Amendments to the Drawings:

The attached two replacement sheets of drawings includes changes to FIGS. 6 and 16.

FIG. 6

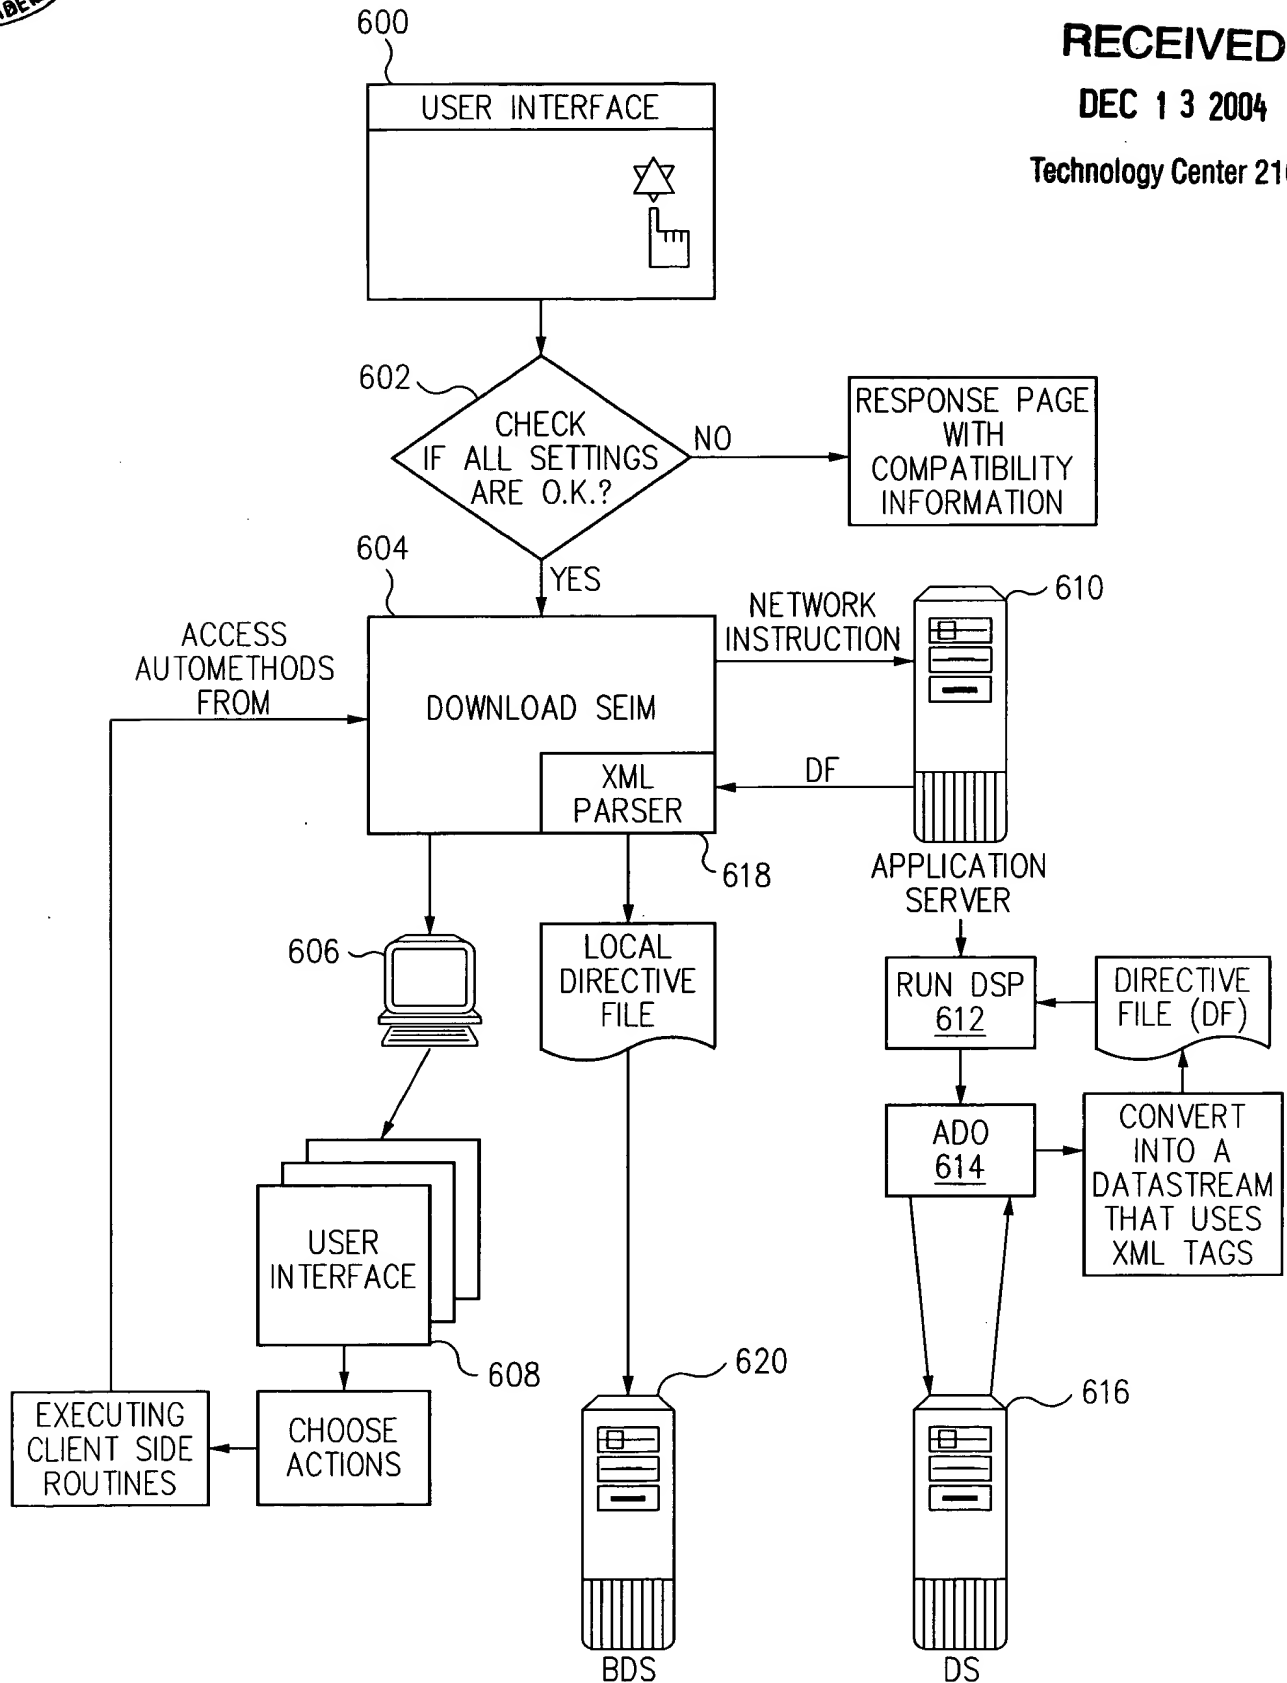
In FIG. 6, near the lower right of the figure, the "RUN DSP 812" has been changed to --RUN DSP 612-- and "ADO 814" has been changed to --ADO 614-- to secure correspondence with the specification.
